INDEPENDENT REVIEW OF HUMAN  
HEALTH RISK ASSESSMENT  
DOWE'S QUARRY, TENTERFIELD

Tenterfield Shire Council

16 March 2021

Job Number 21011234

Figure 3-1: Residential receptor locations

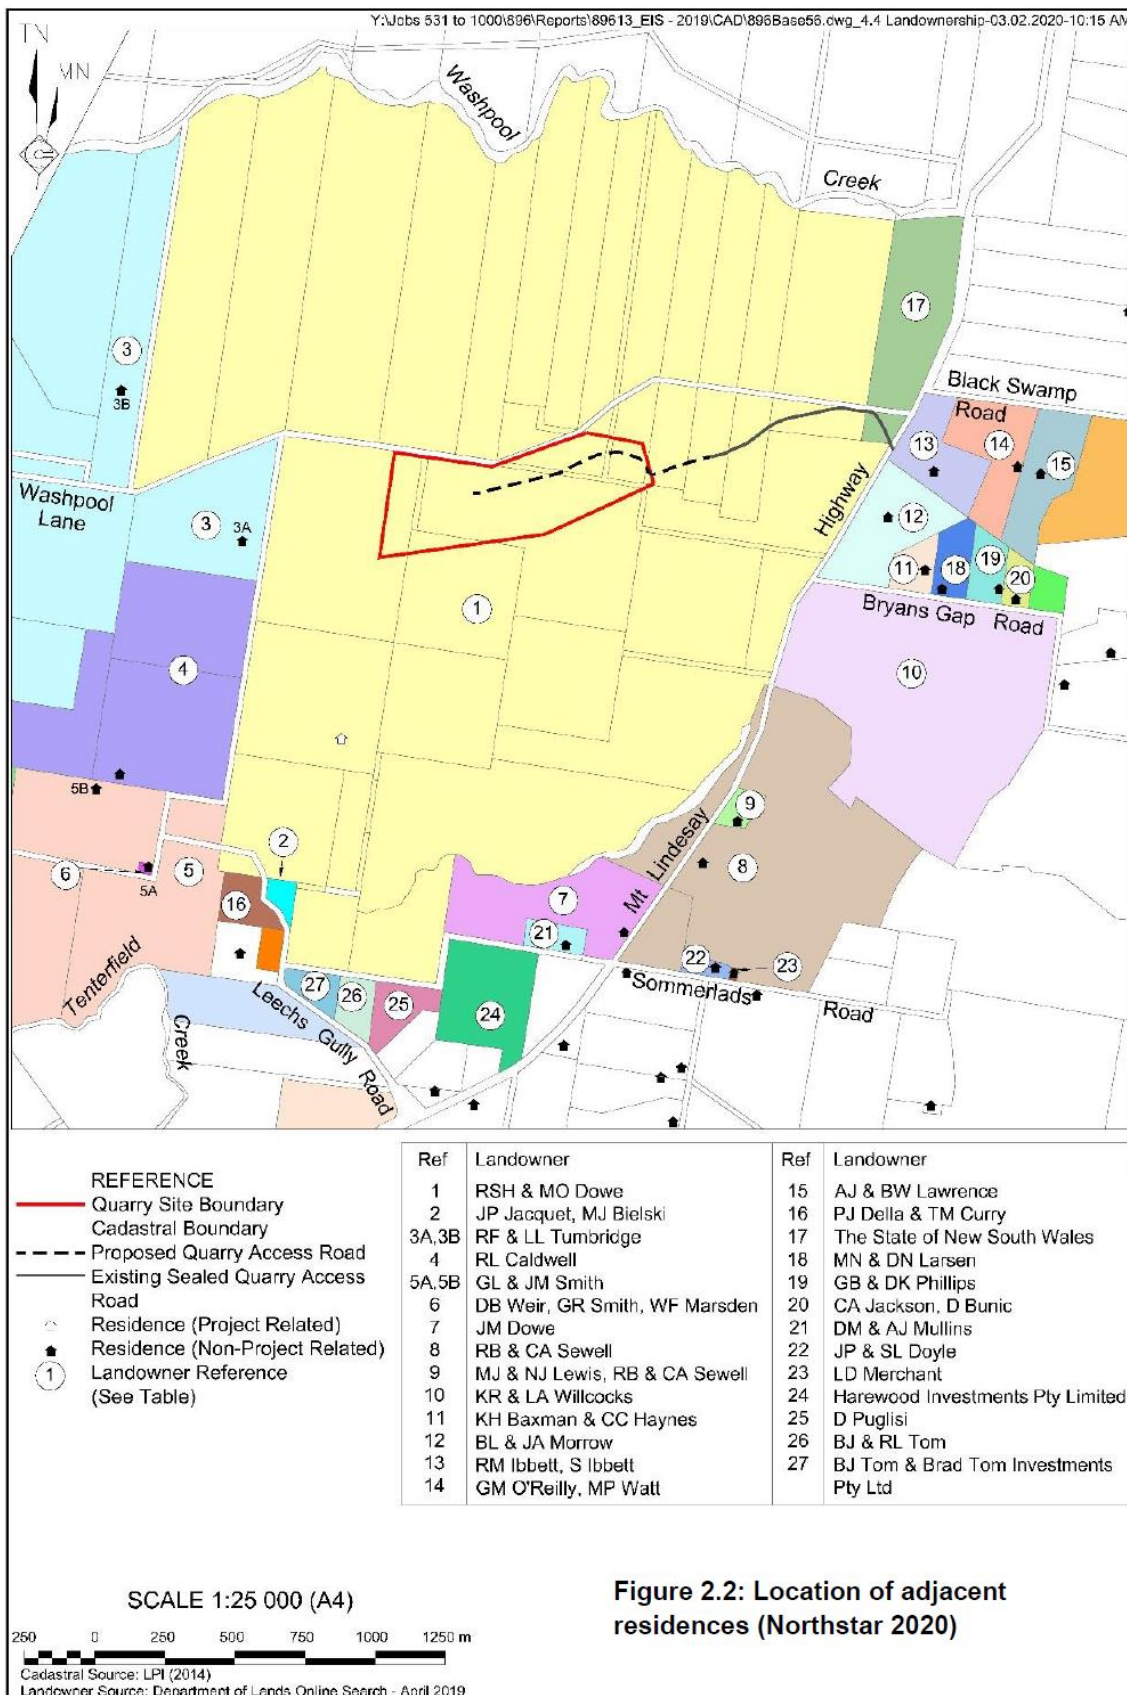
Particulate respirable crystalline silica is investigated at three key residential properties surrounding the quarry in the HHRA, including:

- ✦ Property 12 (BL & JA Morrow);
- ✦ Property 13 (RM & S Ibbett); and
- ✦ Property 3A (RF & LL Tumbridge).

These nearest properties are located approximately 1300m from the boundary to the east and approximately 540m to the west. **Figure 3-1** presents the location of the properties relative to the Project. Note that property 1 is part of the Project.

**Table 3-1** presents a summary of the predicted air quality levels at the receptors (taken from the AQIA and HHRA). These receptors are the closest identified receptors to the Project and would experience the highest dust levels.

The maximum off-site PM<sub>2.5</sub> concentration for all dust due to the Project is 0.2µg/m<sup>3</sup> and is predicted at the most impacted residential receptor. This is 15 times below the guideline level for respirable crystalline silica alone and shows that the Project would comply with criteria by a large margin.
